# ADDENDUM No. 1

ITB No. 4618

## Landfill Scale and Entrance Improvements

# LANDFILL SCALE AND ENTRANCE IMPROVEMENTS

DRAWN BY: EAD / W/N	CONTRACT NUMBER:
CHECKED BY: LAM	SHEET NO:
DATE: 12-01-94	DRAWING NUMBER: S5
SCALE: 1/4" = 1'-0"	REV. A

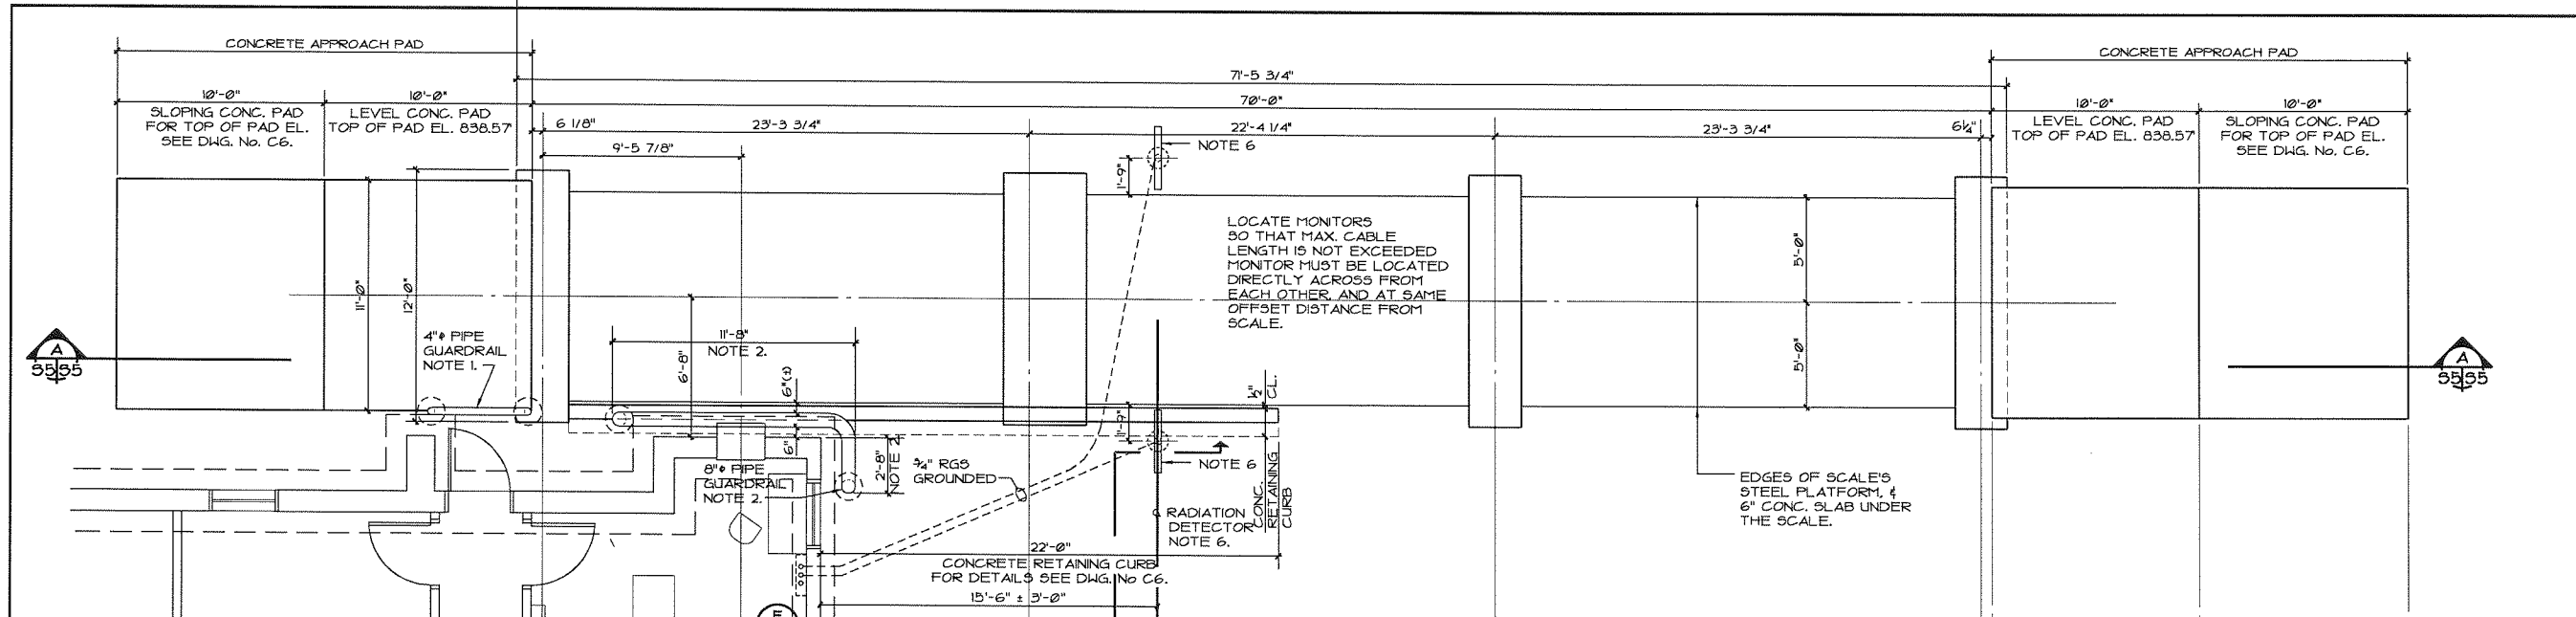
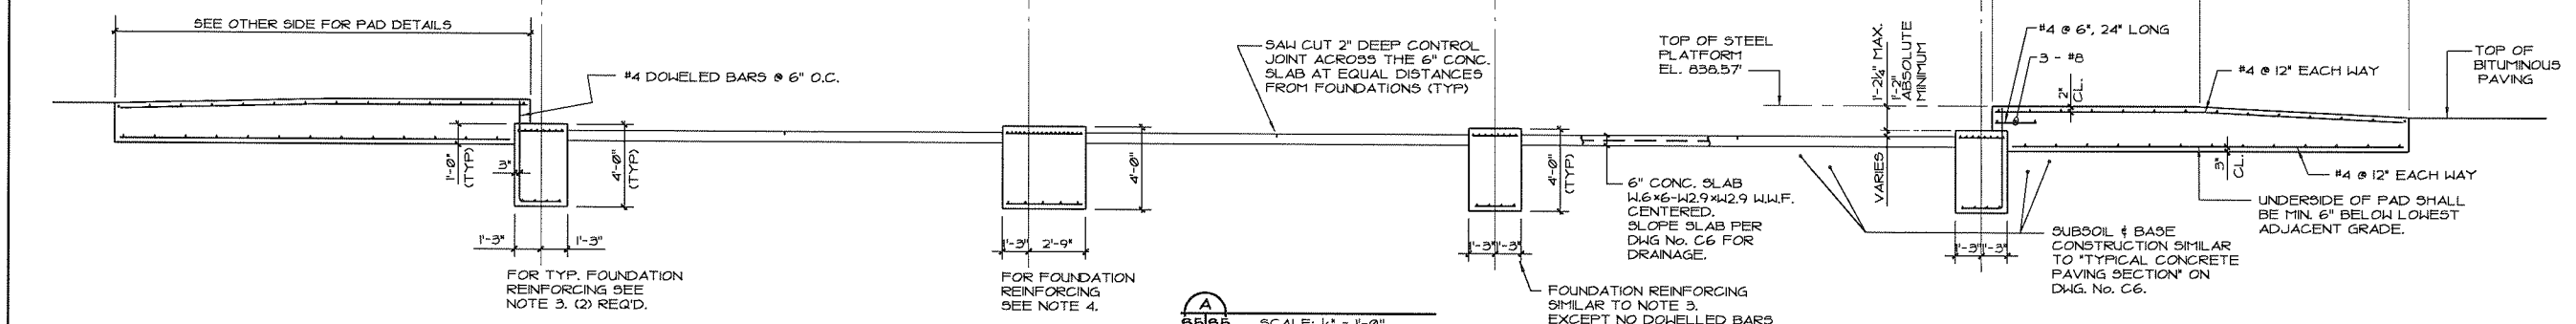
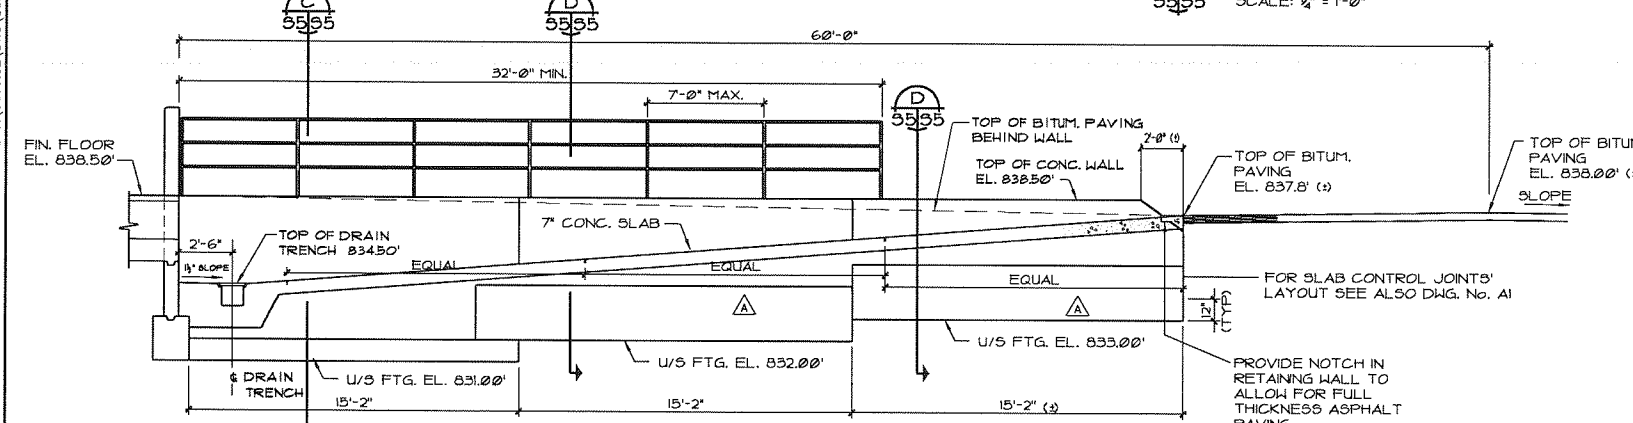
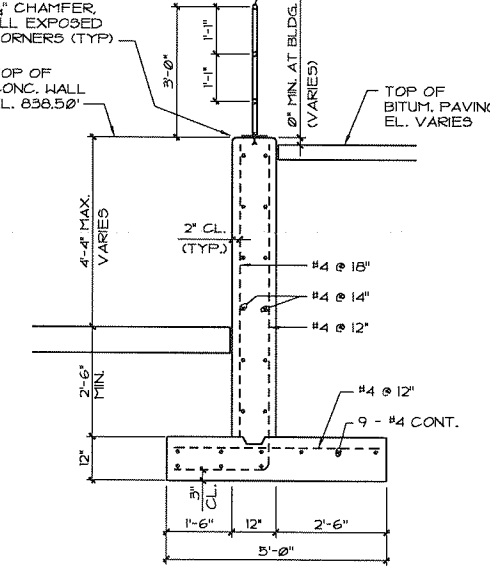
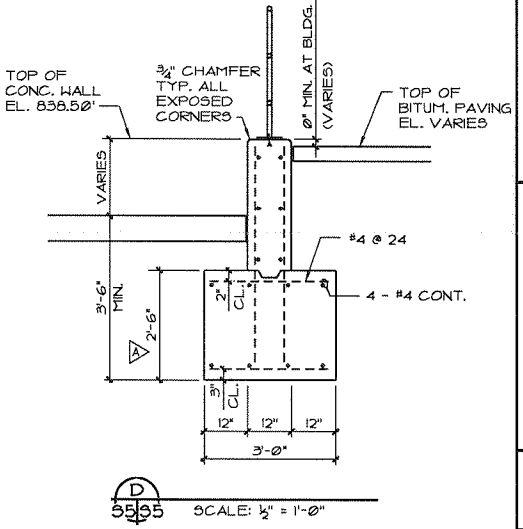
Please provide the drawings of the existing scale installation as specified in Section 01 1100 (this information was to be provided in the Appendix section, but it is not present).

Per specifications, "Demolish, remove and recycle existing scale after the successful operation of the new scales." Existing foundation removal is required ONLY to allow paving/patching the existing scale area (complete removal of foundation is not required).

Existing Scale drawings labeled Drawing Number: S5 – Rev. A is attached to this addendum.
